Eliminating Noise Symptoms - Replacing Rubber Stops on Front Hood (Creaking noise from around the dashboard or A-pillar/SY0116)

Vehicle type: **Macan (95B)**

Model Year: **As of 2014 up to 2016**

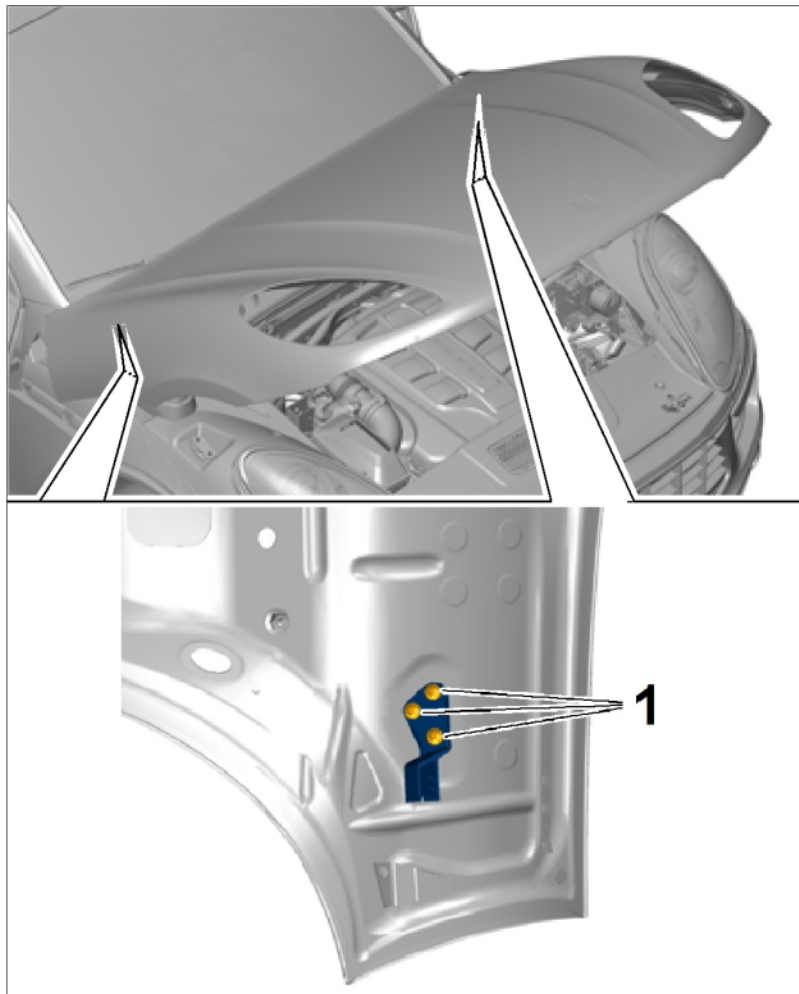
Symptom: Creaking noises come from around the dashboard/A-pillar while driving.

Cause: Material pairing between the buffers and rear rubber stops on the front hood results in creaking noises from around the dashboard/A-pillar at the left and right.

Date of Introduction: From February 2, 2016 onwards, optimized rubber stops (new Part No. 95B.863.23x.A) are used during production.

Remedial action: In the event of a complaint, replace both rear rubber stops on the front hood with new rubber stops ⇒ *Workshop Manual '552237 Disassembling and assembling front lid'*.

Tools and Materials: **95B.863.237.A NEW** ⇒ Rubber stop, left
95B.863.238.A NEW ⇒ Rubber stop, right
